## PRODUCT SUPPORT BULLETIN BULLETIN NO. 316

MACHINE: **Model C Spike Driver**

SUBJECT: **Logic Box Isolation Mount Kit - 98410073**

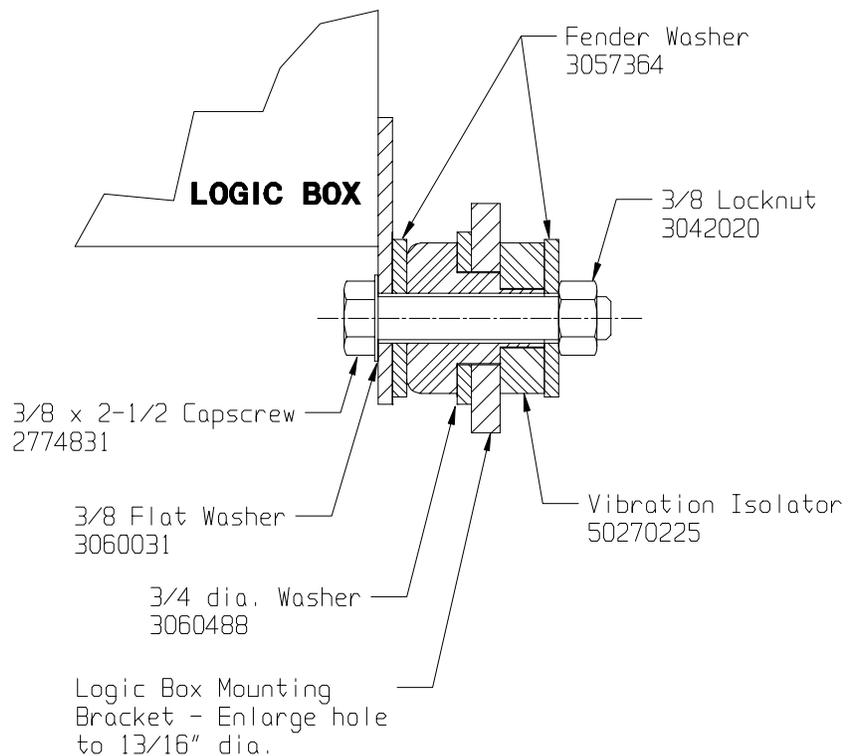
This Logic Box Isolation Mount Kit has been developed to reduce machine vibrations being transmitted to the logic box. Reducing vibrations in the logic box will help prevent failures due to intermittent open circuits in the circuit board to motherboard connections as well as other electrical connections.

The kit consists of 4 **Vibration Isolators, p/n 50270225, mounting hardware and instructions.** The existing logic box mounting holes must be enlarged to 13/16" diameter to receive the isolation mounts. Installation of this kit should take less than an hour.
